Economic Commission for Europe**Inland Transport Committee****World Forum for Harmonization of Vehicle Regulations****Working Party on Lighting and Light-Signalling****Eighty-third session**

Regulations Nos. 37 (Filament lamps), 99 (Gas discharge light sources), 128 (Light emitting diodes light sources) and the Consolidated Resolution on the common specification of light source categories

Proposal for amendment to the Consolidated Resolution on the common specification of light source categories**Submitted by the expert from the International Automotive Lighting and Light-Signalling Expert Group***

Sheet Lx3/1, figure 1, amend to read:

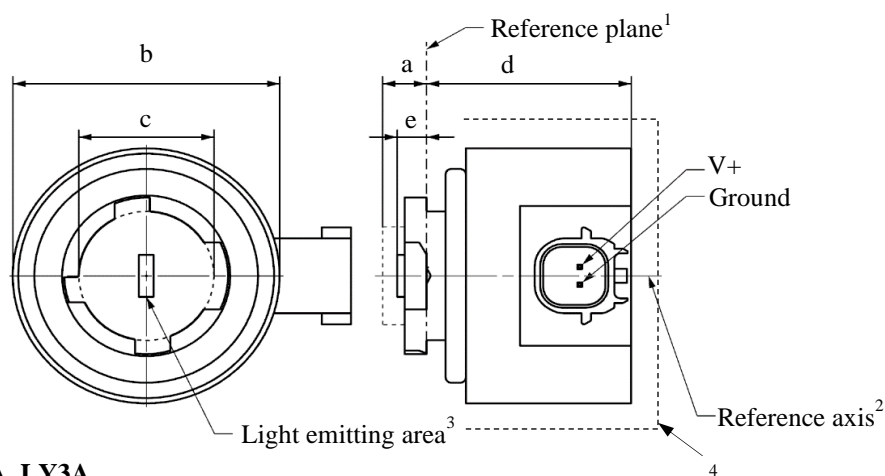
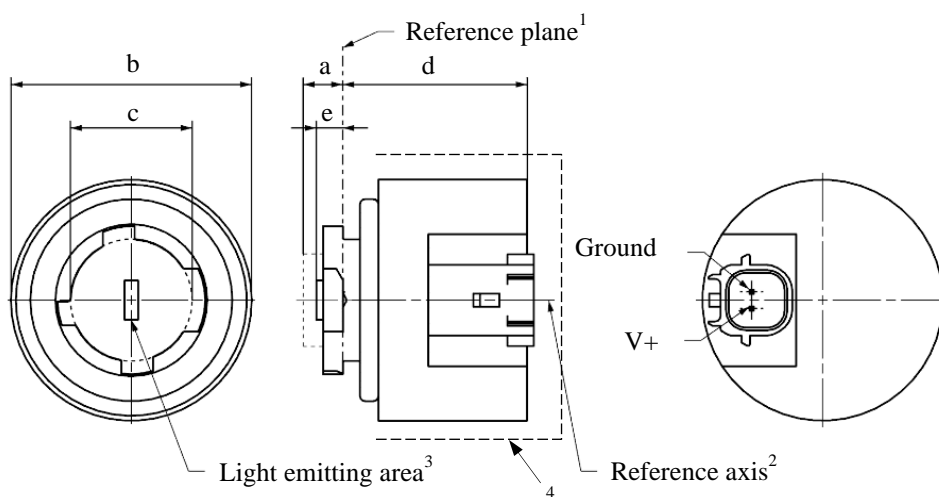
- (i) Replacement of Figure 1 with figures similar to the figures used for category L1/6;
- (ii) Deletion of the row with the dimension h from in Table 1;
- (iii) Alignment of the Figure 3 “Set-up to measure the luminous intensity distribution” with the Figure 1 to avoid confusion.

Sheet Lx3/2, table 1 and footnote 4, amend to read:

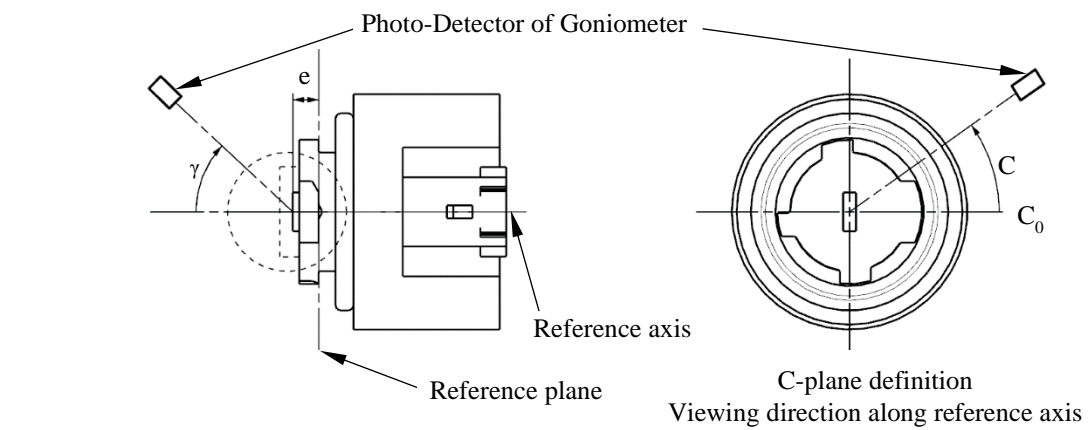
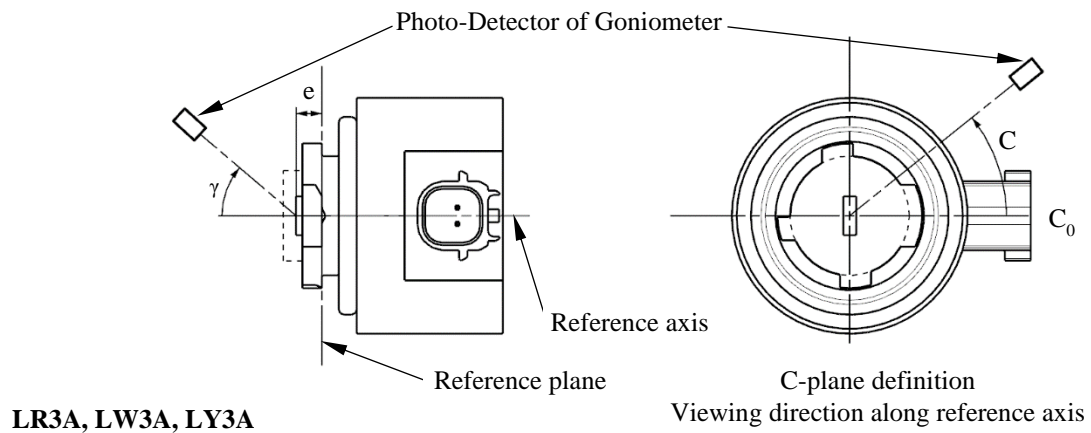
4/ A minimum free air space of 5 mm around the light source shall be respected for convection-; **the connector interface can be neglected.**
